Addendum 02 for RFB 943600-01

Project Name: Terrace Hill Elevator Replacement
DAS RFB #: 943600-01
DAS Project #: 9436.00
Date: 1/30/2025

State of Iowa
Terrace Hills Elevator Replacement
Addendum #2
01/29/2025

ELECTRICAL - LEVEL 2
1/4" = 1'-0"

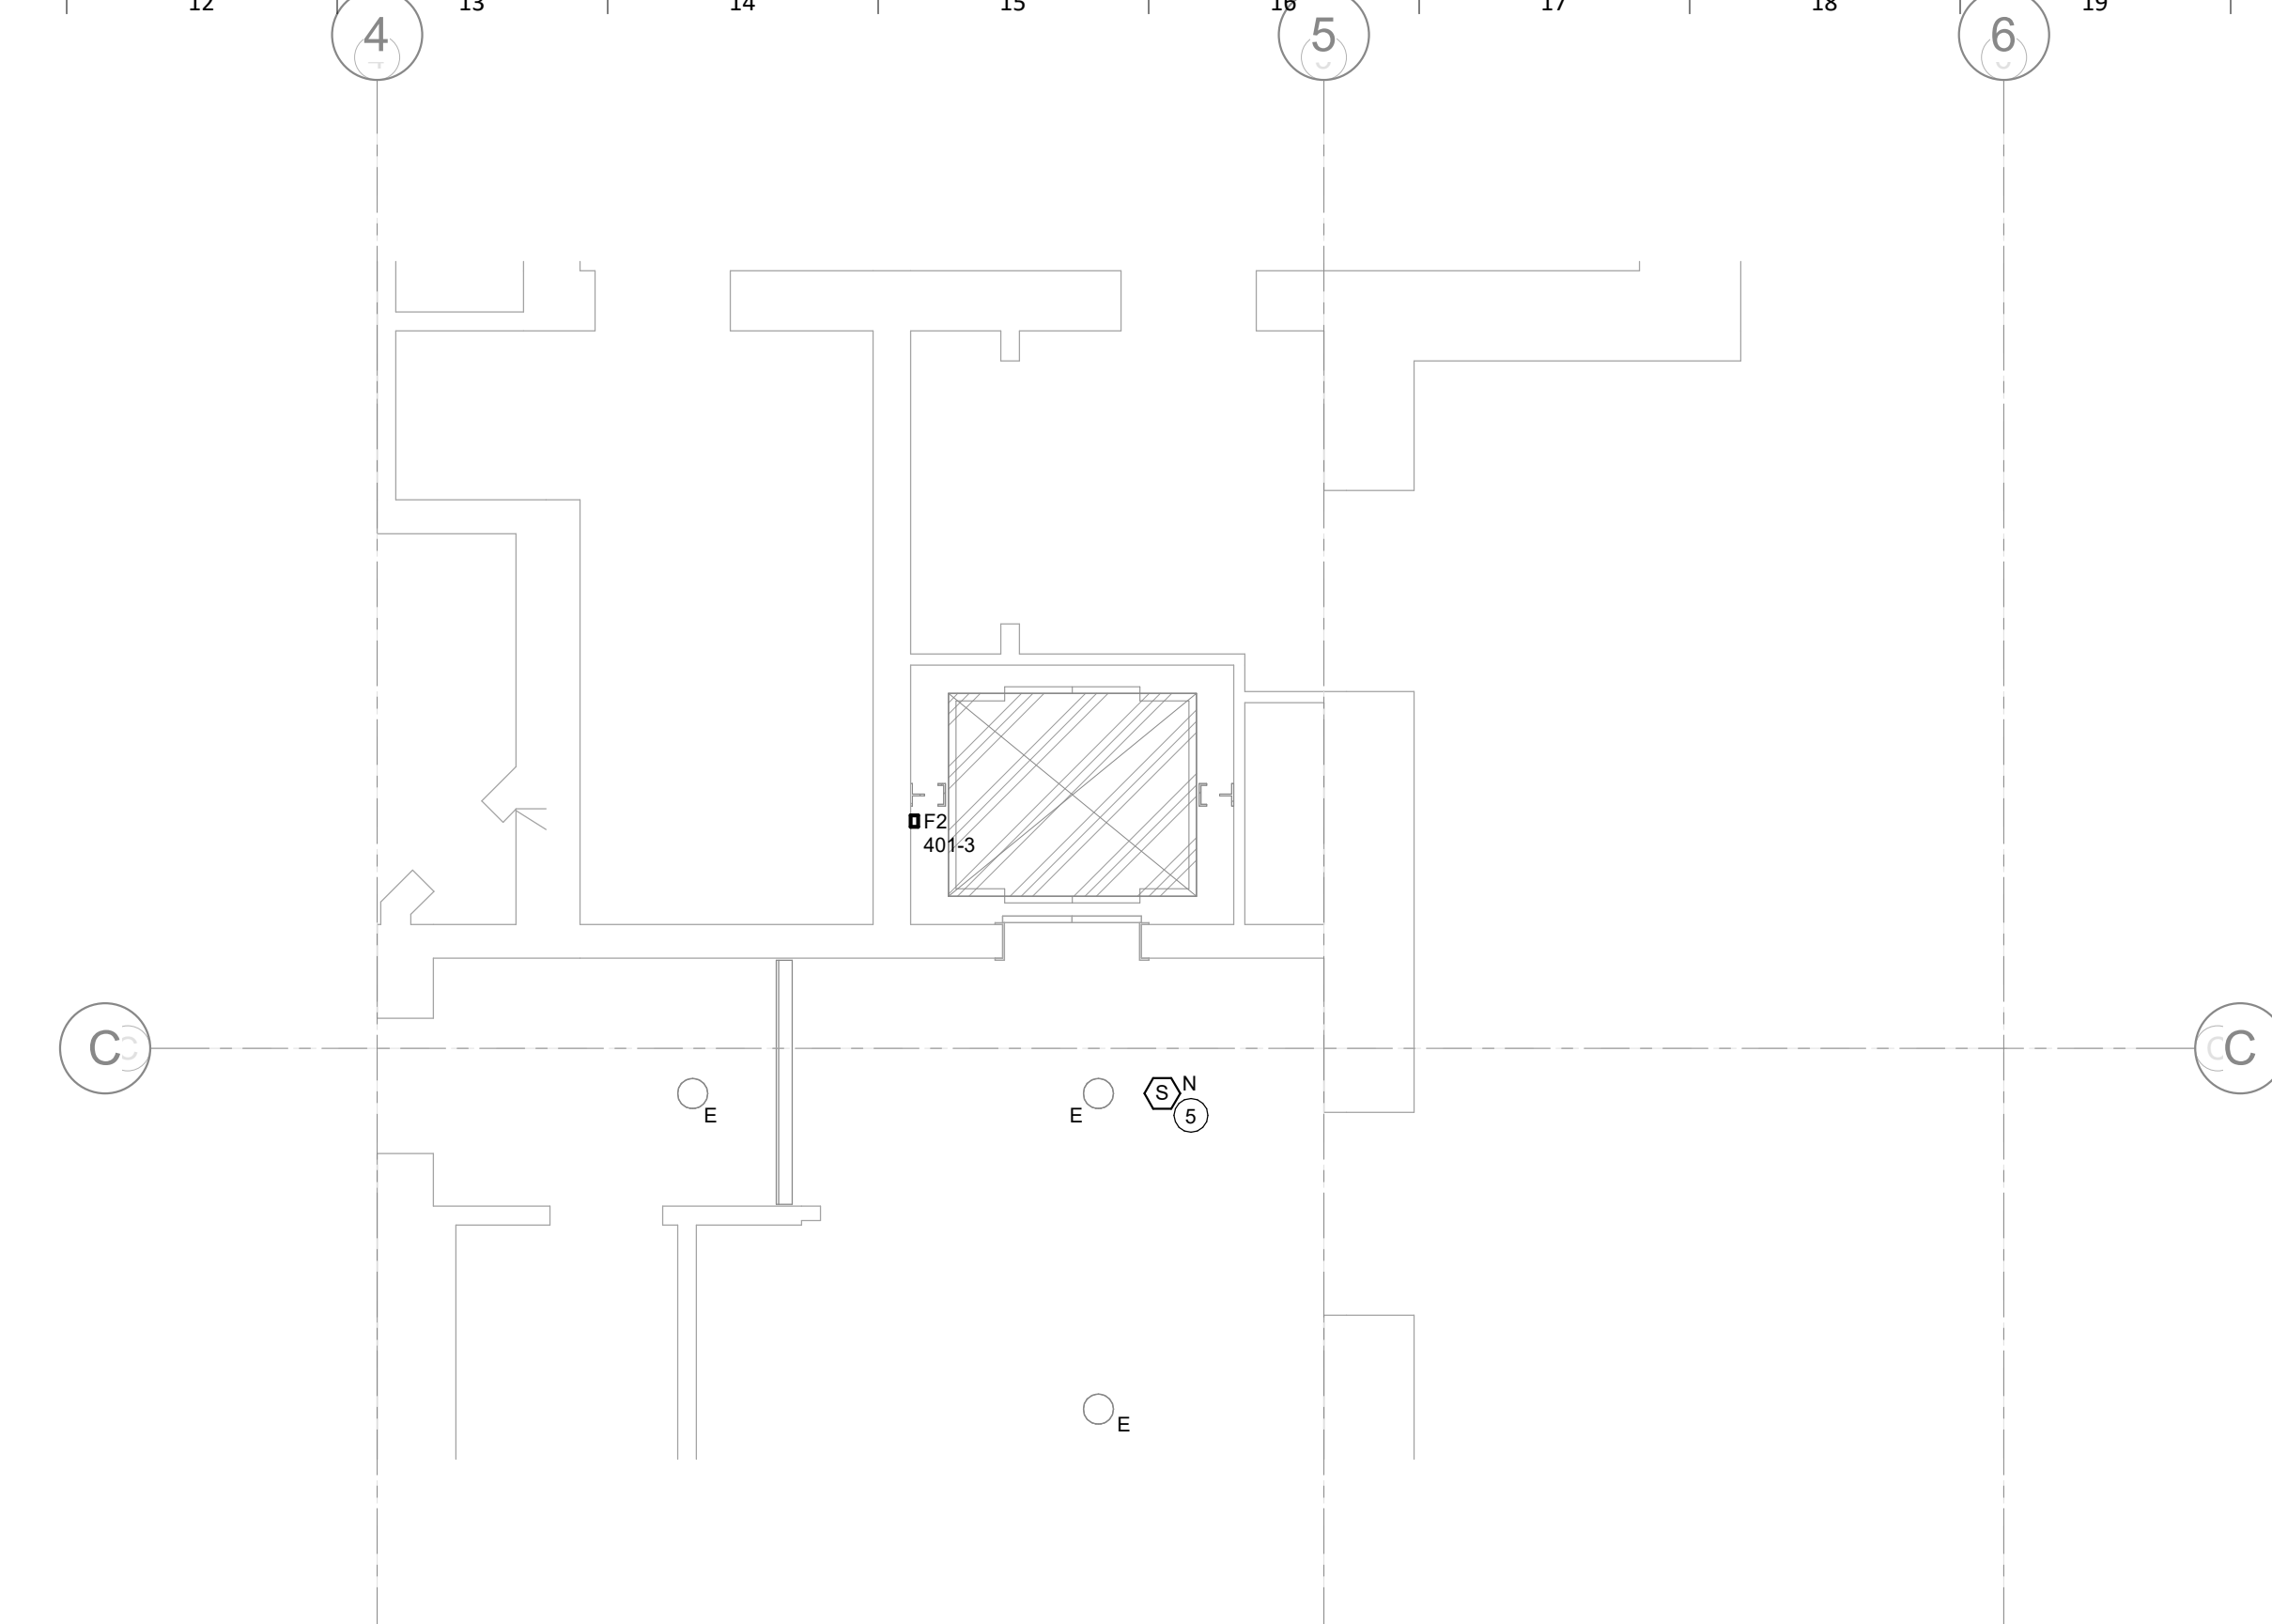
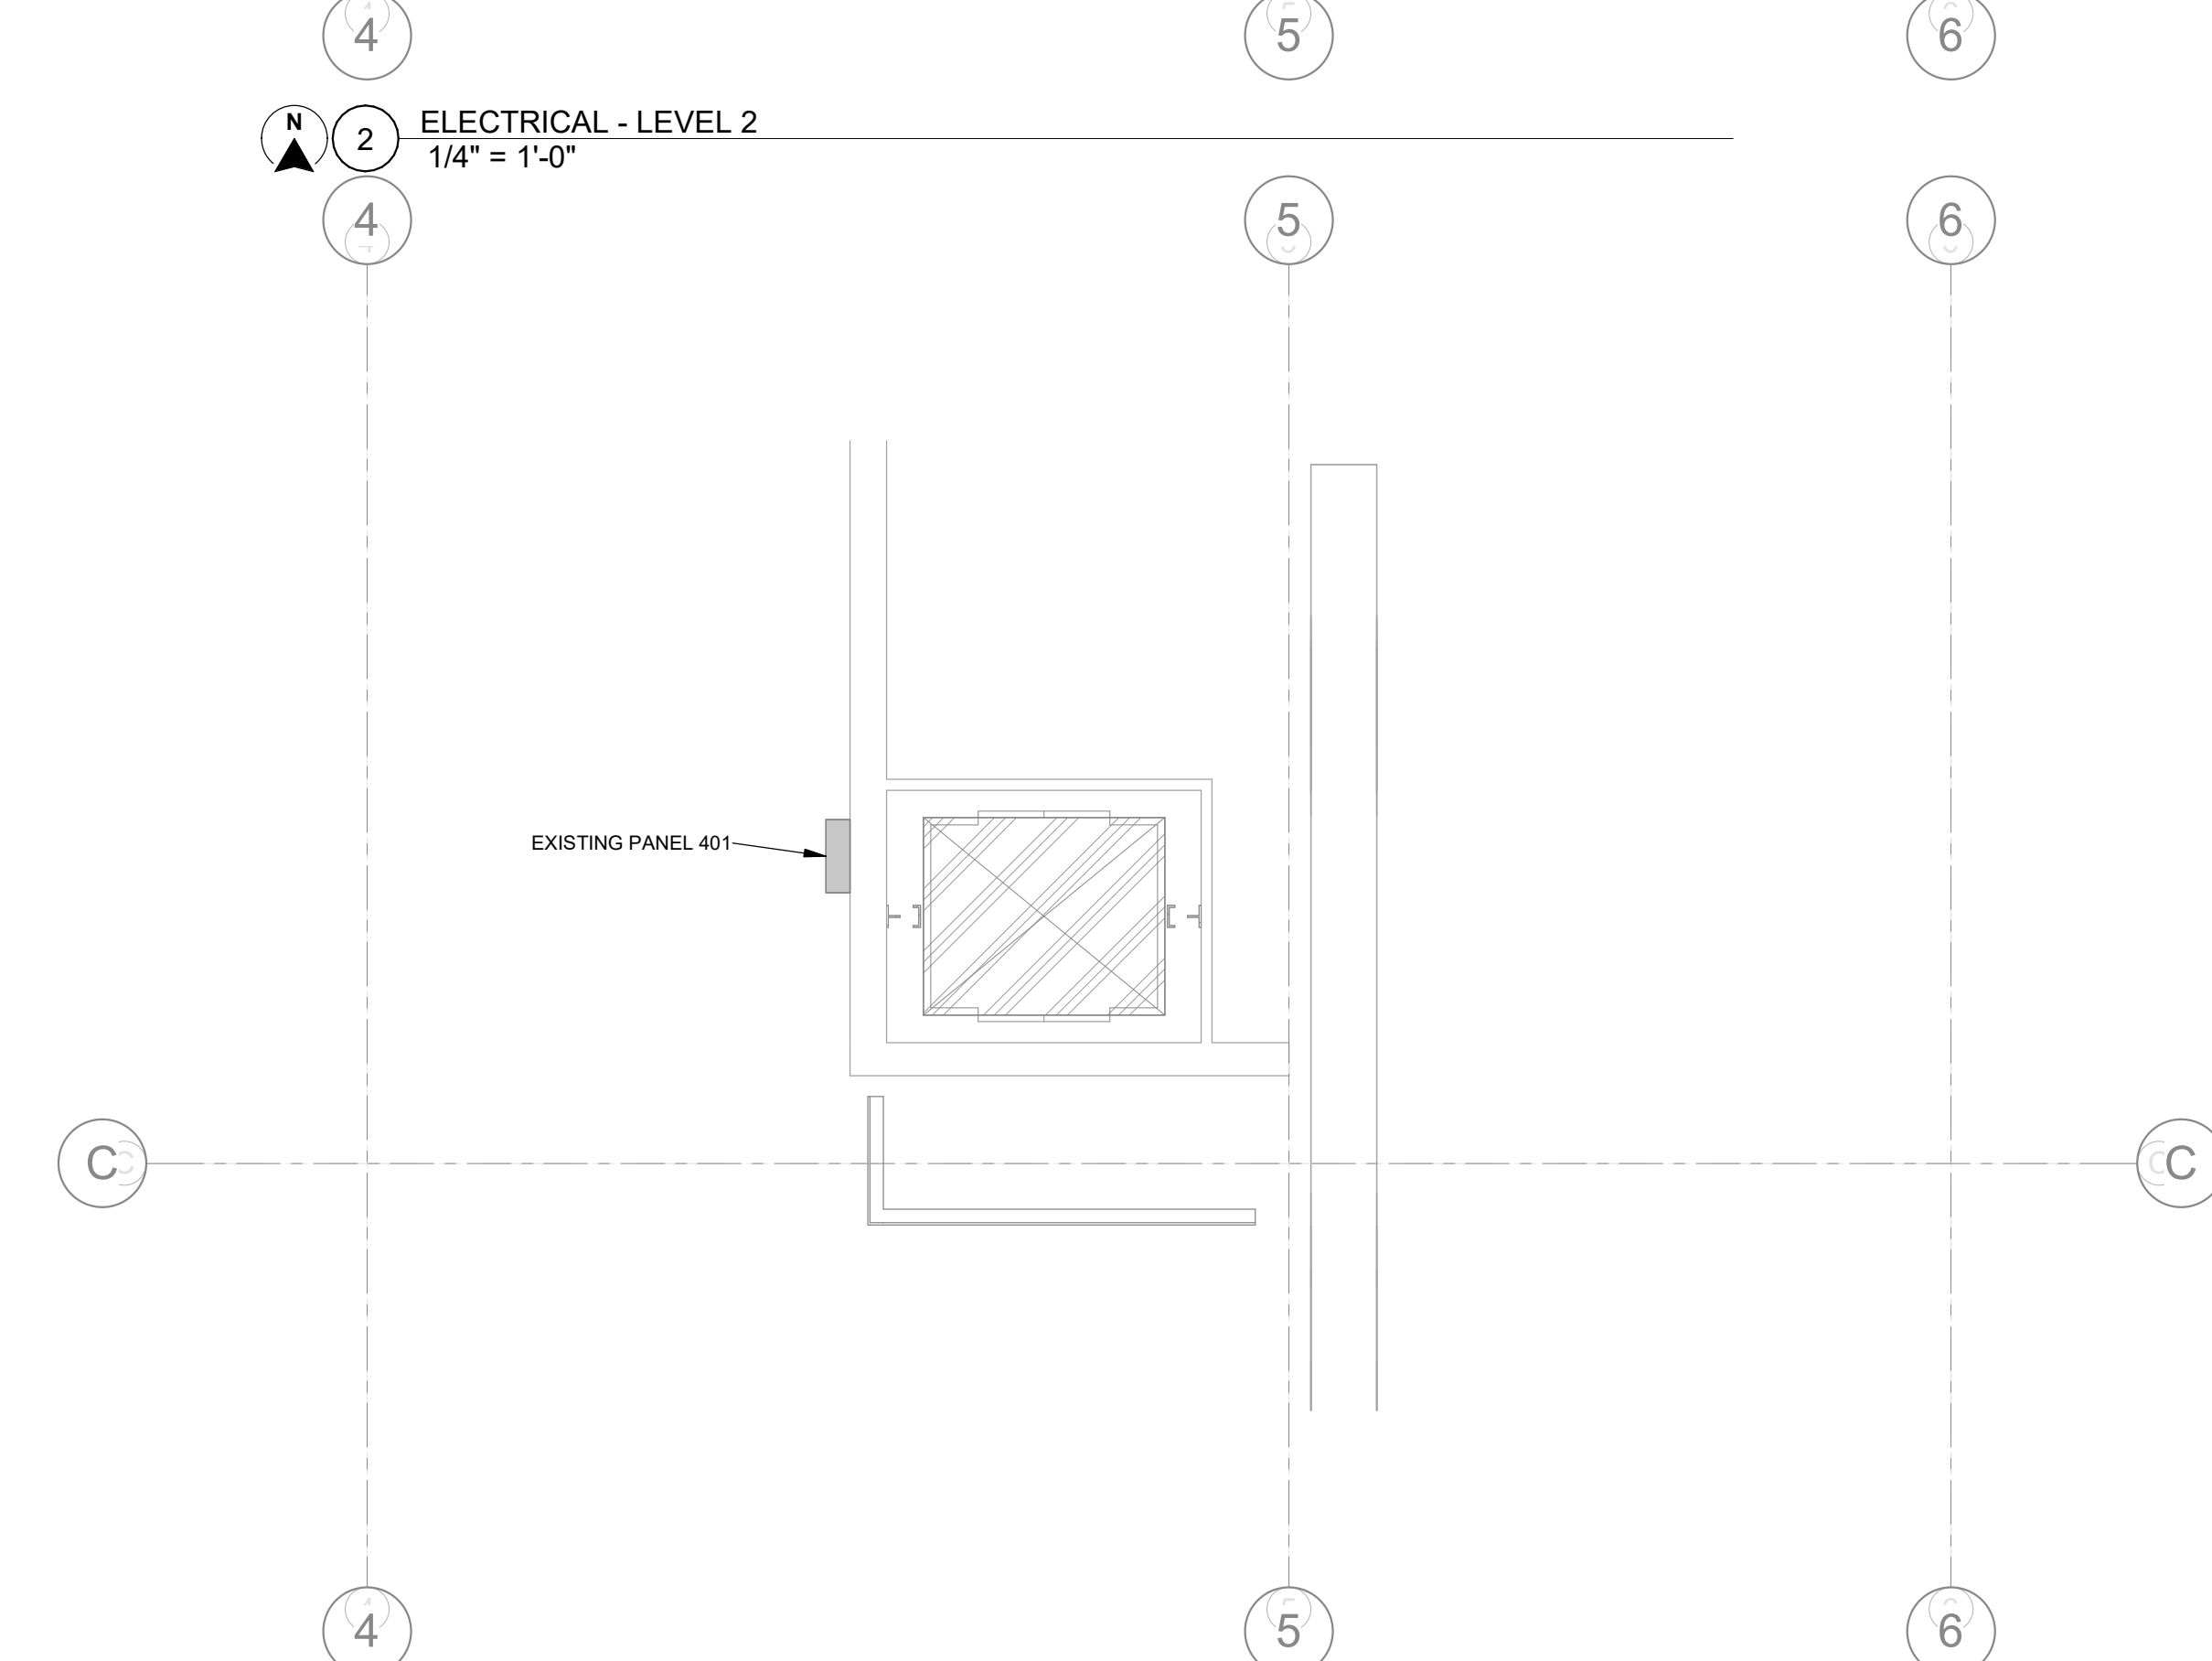
1. Drawing E101 – ELECTRICAL SHEET
 - a. CLARIFY IDF location in basement for installation of the new data cabling.
 - b. REVISE circuit for the lighting in the elevator shaft to the attic panelboard 401.
 - c. REMOVE additional card reader in the elevator cab. Only (1) card access location will be required located on the main elevator control panel.
 - d. Refer to attached full size sheet E101.
